3-5 Trelawney Street - LDA2011/0611
Proposed Conditions of Consent

Agenda of the Planning and Environment Committee Report No. 9/12, dated Tuesday 17 July 2012.

Reason for Referral to Planning and Environment Committee: Nature of the proposed development; and received VPA.

Clause 4.3 - Height of Buildings

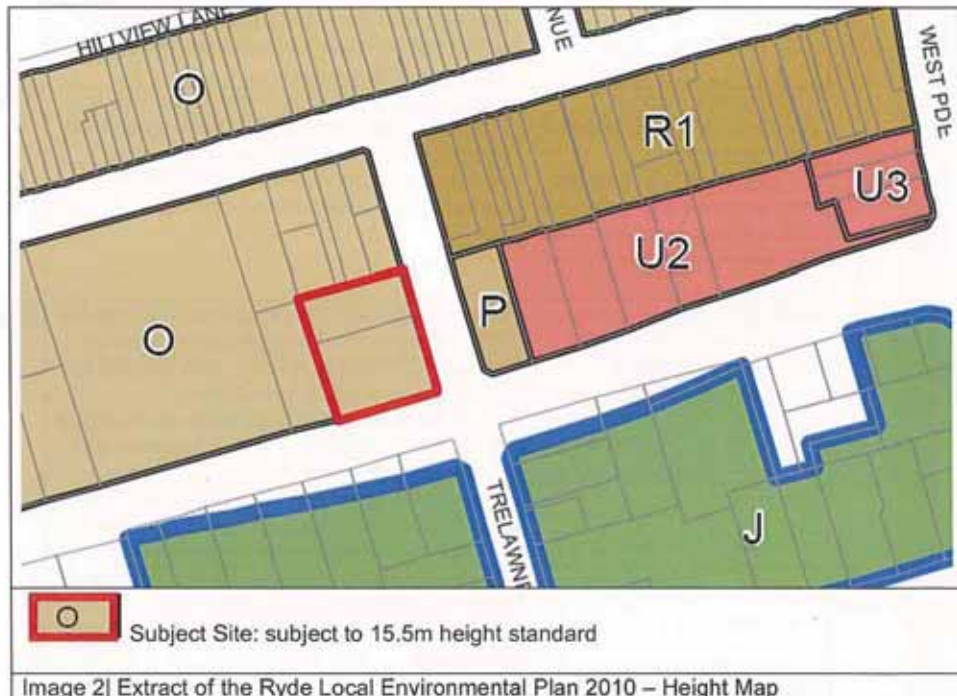
The maximum permissible height applicable to the subject site, as indicated on the RLEP 'Height of Buildings Map' is 15.5m.

Image 4: Extract Ryde Development Control Plan 2010

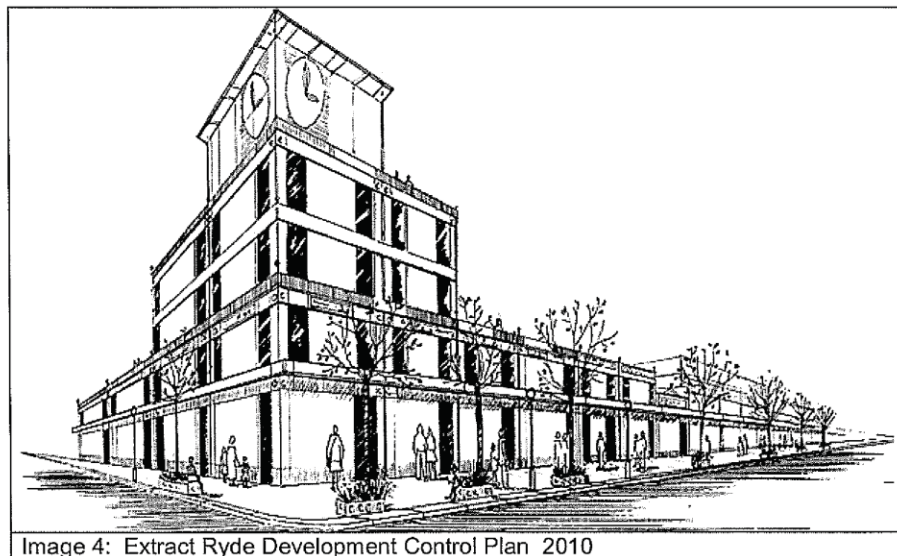
Council's RDCP 2010 provides further details on acceptable design solutions to treating corner sites. As is evident, elements should be limited specifically to defining the sites corner rather than the whole length of a site. It includes the diagram below. Any variance to the height control could be justifiable and likely to be supported in the circumstance of providing appropriate definition to a site's corner.

The specified DCP objective for corner allotments is: *'To ensure buildings situated on corner allotments provide for visual interest and address intersection that they front'*. This supports that the emphasis that buildings should be limited to the corner of the building rather than the whole length of the corner location of the site. In addition, the following controls also support this:
